This Service Information bulletin supersedes SI B11 04 13 **dated November 2013**

Service Action: N14 Engine Check Timing Chain Tensioner and Timing Chain

R55

With the N14 engine

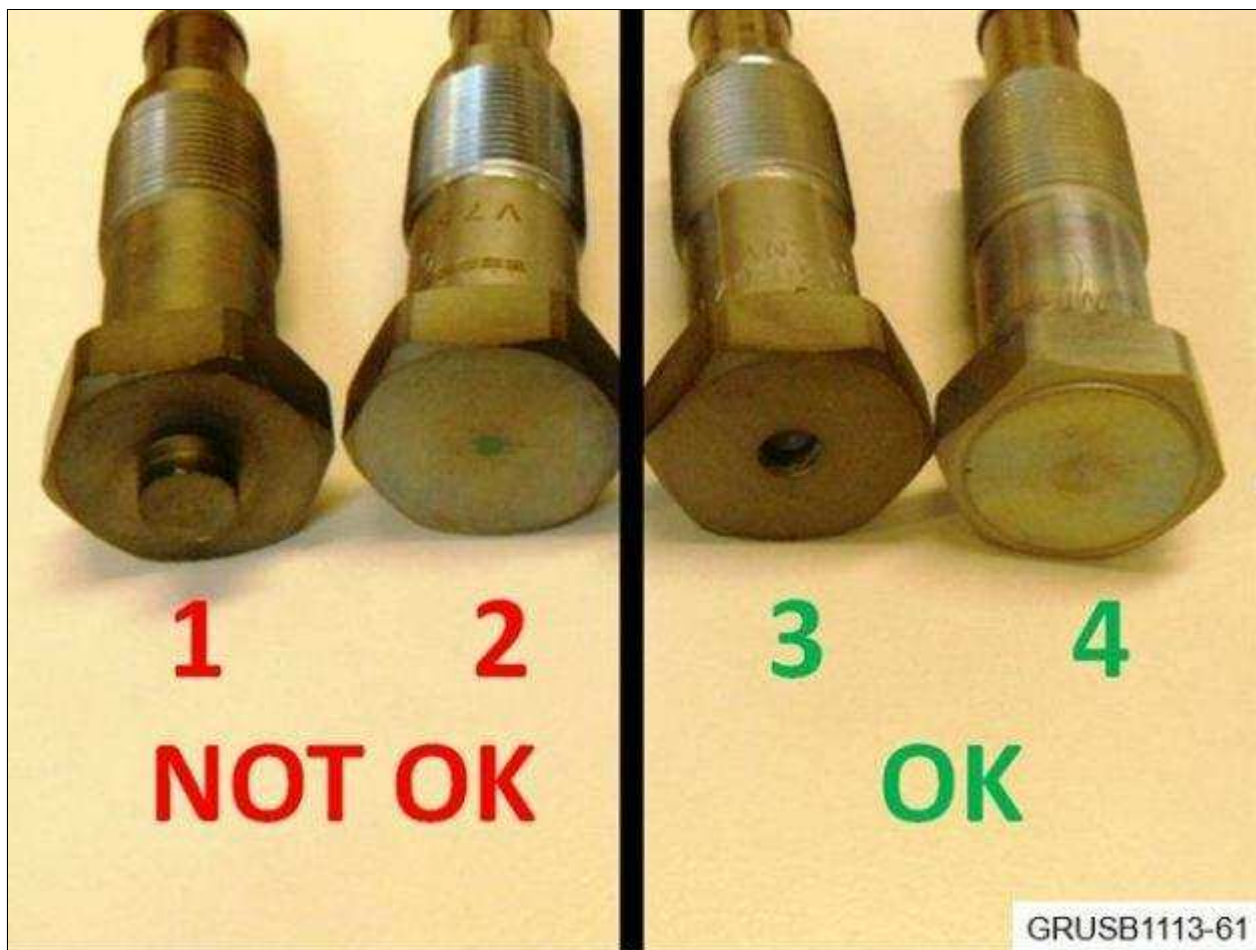
NEW First check the B-pillar Service Action label for code number **61**.

NEW If code number **61** has been punched out, the campaign has already been performed and no further action is necessary.

Item 1: Protruding boss – Not OK	Item 3: Drilled head – OK
Item 2: Flat head, no markings, no holes, no machined edge– Not OK	Item 4: Machined edge in head – OK

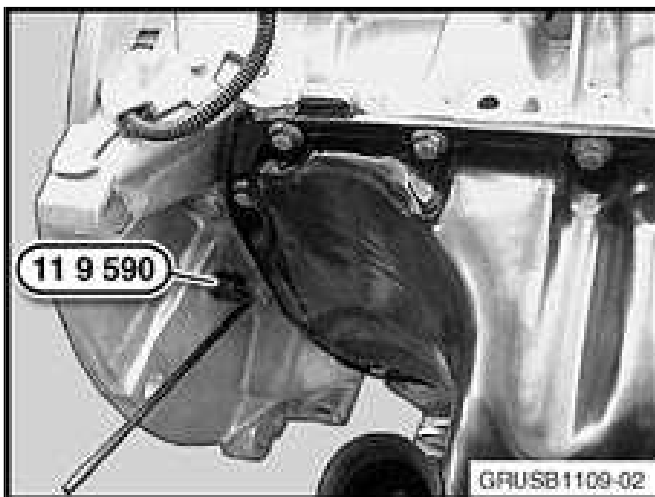
1. The timing chain tensioner will need to be inspected before removal. The timing chain tensioner is visible from above, inside the engine compartment, between the intake tube and air filter housing. One of the following timing chain tensioners may be installed. **Do not remove the timing chain tensioner for the inspection.**

2. **NEW** If the engine is fitted with a timing chain tensioner that has a drilled head (item 3) or has a machined head (item 4), do not replace the timing chain tensioner. No further repairs are needed. If the chain tensioner has a protruding boss (item 1) or a flat head (item 2), proceed to step 3.
3. Remove the right-hand wheel arch trim to access the crankshaft central bolt.
4. Disconnect the battery and remove the ignition coils and spark plugs. Turn the engine in clockwise direction by hand to move the flywheel approximately 90° before TDC. Rotating the engine counterclockwise may cause an incorrect measurement.

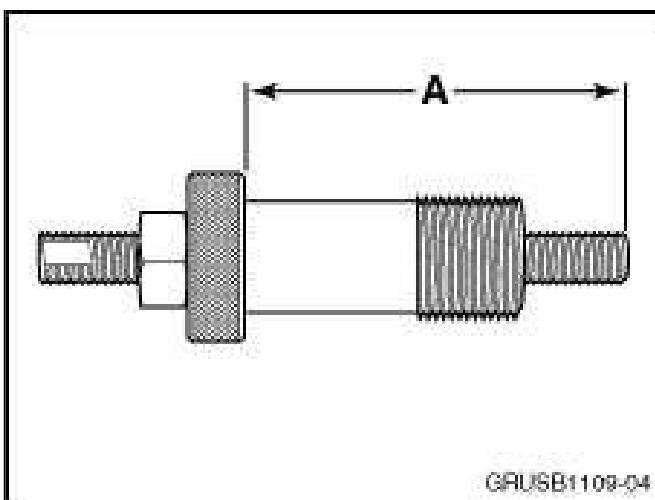
6. Fit the chain tensioner (Special Tool 11 9 340) without the seal ring and with the lock nut loose. Pretension the chain tensioner with Special Tool 00 9 250 to 0.6 Nm. Finger-tighten the M10 lock nut on Special Tool 11 9 340.

Gently turn Special Tool 00 9 250 while applying the torque. Quickly rotating the tool will provide an inaccurate measurement result.

7. Remove chain tensioner Special Tool 11 9 340 from the engine, with the lock nut still tight. Measure the distance (A), as described in the illustration.

8. If distance A is less than 68 mm, replace the chain tensioner with sealing ring P/N 11 31 4 609 482 (refer to parts list A).
9. If distance A is 68 mm or greater, replace the components below, found in the Timing Chain Repair Kit P/N 11 31 8 623 601 (refer to parts list B):
 - Timing chain tensioner
 - Sealing ring
 - Timing chain
 - Guide rail
 - Tensioner rail
 - Sliding rail
 - Sprocket on the crankshaft
 - Bearing bolts for the tensioner and guide rails

LABEL INSTRUCTIONS

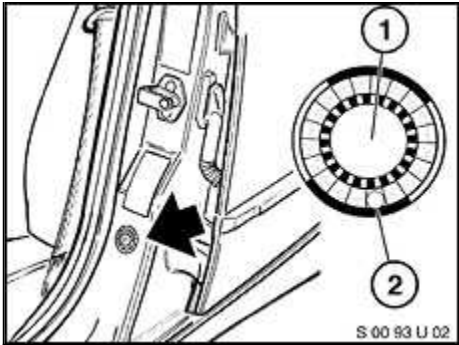
<p>This Service Action has been assigned code number 61. After the vehicle has been checked and/or corrected, obtain a label (MD20-064) and:</p> <ol style="list-style-type: none"> Emboss your MINI dealer warranty number in the middle of the label (1); Punch out code number 61 (2), printed on the label; and Affix the label to the B-pillar as shown.
--	--

If the vehicle already has a label from a previous Campaign, affix the new label next to the old one. Do not affix one label on top of another one, because a number from an underlying label could appear in the punched-out hole of the new label.
